Access Compliance Report

Public Rights-of-Way

Intersection ID: 18848	Main Street: TYVOLA_RD	Cross Street: TYVOLA_RD	Location: SW
ADA ID: B05D45372D01	Ramp Type: Perp	Initial Pass/Fail: Fail	Overall Compliance: No
		Severity Score: 37.5

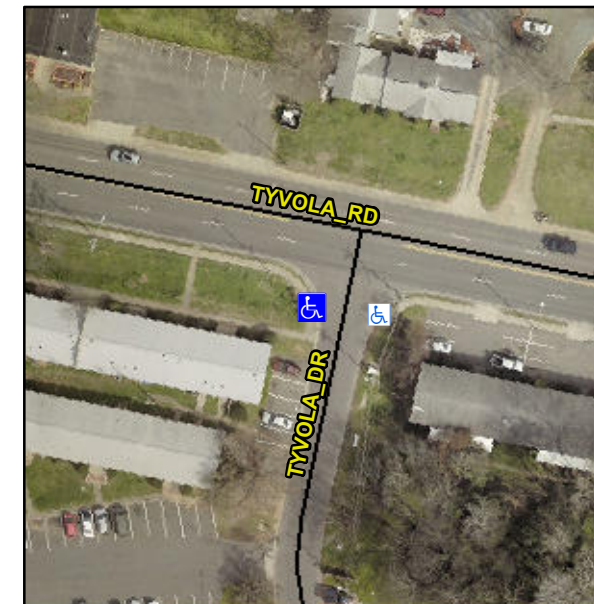
Not Found, R304.2.2, R304.5.3

Compliance	Description	Data	Compliance	Description	Data
N/A	Ramp Length (in)	57.5	No	Ramp Slope (%)	10.6
Yes	Ramp Width (in)	48.0	No	Ramp XSlope (%)	7.4
N/A	Flare Type LT	N/A	N/A	Flare Type RT	N/A
N/A	Flare Slope LT (%)	N/A	N/A	Flare Slope RT (%)	N/A
N/A	Flare Traversable LT?	N/A	N/A	Flare Traversable RT?	N/A
N/A	Landing Length (in)	N/A	N/A	DWS Provided?	N/A
N/A	Landing Width (in)	N/A	N/A	DWS Contrast?	N/A
N/A	Landing Slope (%)	N/A	N/A	DWS Length (in)	N/A
N/A	Landing X Slope (%)	N/A	N/A	DWS Full Width?	N/A
N/A	Landing Curb? (Y/N)	N/A	N/A	DWS Offset (in)	N/A
N/A	Shared Landing?	N/A			
N/A	Gutter Ponding?	N/A	N/A	Gutter Slope (%)	N/A
N/A	Gutter Lip Ht (in)	N/A	N/A	Gutter X Slope (%)	N/A
N/A	Painted X Walk1?	No	N/A	Painted X Walk2?	N/A
	X Walk 1 Direction	To SE		X Walk 2 Direction	N/A
N/A	X Walk 1 Width (in)	N/A	N/A	X Walk 2 Width (in)	N/A
	X Walk 1 Slope (%)	0.6		X Walk 2 Slope (%)	N/A
	X Walk 1 X Slope (%)	5.6		X Walk 2 X Slope (%)	N/A

Remove & Replace Entire Ramp.
